UNITED STATES PATENT AND TRADEMARK OFFICE

APPLICATION NO.	FILING DATE	FIRST NAMED INVENTOR	ATTORNEY DOCKET NO.	CONFIRMATION NO.
10/820,737	04/09/2004	Jong-eun Chae	1572.1290	9002

DETAILED ACTION

(Illustration of Figure 3)

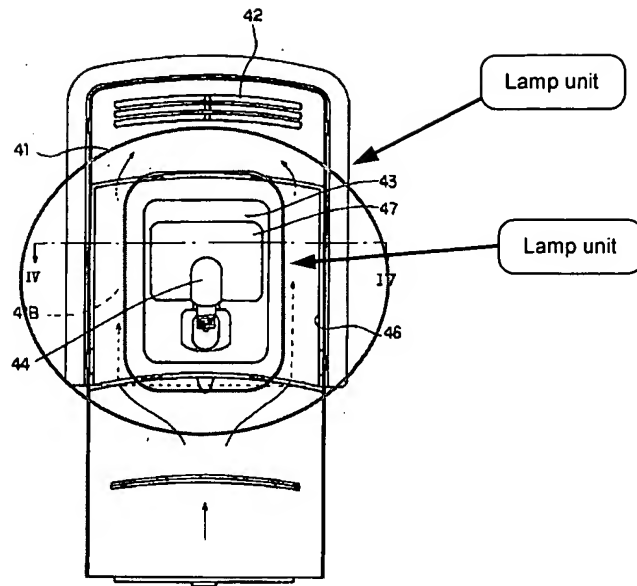
Regarding claim 1, Kiyoshi discloses a refrigerator (1 – domestic refrigerator) comprising a main body (2 – heat insulation box) formed with a storing compartment (12 – freezer compartment) (as seen in Figure 2); a first cool air duct (flow path that begins beneath condenser [24] and ends above condenser room [23]; Figure 1) provided in a rear of the main body (as seen in Figure 1); a lamp unit (as seen in the illustration of Figure 3 below) mounted in an upper part of the main body (as seen in Figure 1) and comprising a lamp (44 – unnamed element) and a lamp case (as seen in Figure 3); the lamp case extending from the rear of the main body to a front of the storing compartment of the main body (as seen in Figure 1); and a second cool air duct (40 – duct) that is formed in an upper part of the lamp case to communicate with the first cool air duct (as seen in Figure 1) and allows cool air flowing through the first cool air duct to flow out at the front of the storing compartment of the main body (as seen in Figure 1).

Regarding claim 2, Kiyoshi discloses the second cool air duct is formed in the lamp case as one body (as seen in Figure 1).

Regarding claim 3, Kiyoshi discloses the second cool air duct is detachably formed in the lamp case (see paragraph 0013 of the translated description).

Regarding claim 7, Kiyoshi discloses the second cool air comprises an upper case (43 – crater) and a lower case (45 – illumination room) engaged to each other (as seen in Figure 4).

(Illustration of Figure 1)

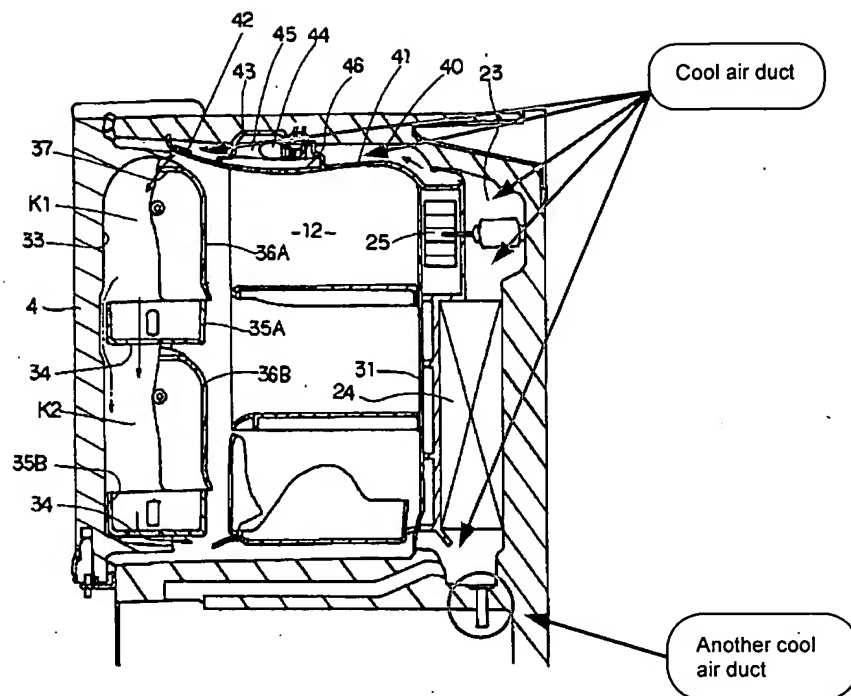
Regarding claim 11, Kiyoshi discloses an air chamber (46 – wrap transparence cover) located at a front of the lamp unit and coupled to the second cool air duct (as seen in Figure 1), wherein the cool air from the second cool air duct is discharged through the air chamber to the front of the storage compartment (as seen in Figure 1) and the air chamber includes a discharge grate (42 – outlet) to disperse the cool air evenly across the front of the storage compartment (a seen in Figures 1, 3).

Regarding claim 12, Kiyoshi discloses a refrigerator (1 – domestic refrigerator) comprising a main body (2 – heat insulation box) housing a plurality of refrigeration components (as seen in Figures 1, 2) and a climate controlled storage compartment (stockroom, paragraph 0009) that includes an opening selectively covered by a door (5, 6 – doors) (as seen in Figure 2); a lamp unit (as seen in the illustration of Figure 3 above) mounted above the storage compartment (as seen in Figures 1, 2), the lamp unit extending from a rear of the storage compartment to a front of the storage compartment (as seen in Figure 1); a cool air duct (as seen in the illustration of Figure 1 below) contiguous with the lamp unit (as seen in Figure 1) wherein the cool air flowing from the plurality of refrigeration components is discharged to a front of the storage compartment by the cool air duct (as seen in Figure 1); and an air chamber (46– wrap transparence cover) located at a front of the lamp unit and coupled to the cool air duct (as seen in Figure 1), wherein the cool air from the cool air duct is discharged through the air chamber to the front of the storage compartment (as seen in Figure 1).

Regarding claim 13, Kiyoshi discloses the cool air duct comprises a lower air duct (flow path that begins beneath condenser [24] and ends above condenser room [23]; Figure 1) and an upper air duct (40 – duct) coupled together and demountably combined with the lamp unit (see paragraph 0013; Figure 1).

Regarding claim 20, Kiyoshi discloses the climate controlled storage compartment comprises another cool air duct (as seen in the illustration of Figure 1 above) that is

mounted at a rear thereof and in communication with the cool air duct (as seen in Figure 1).
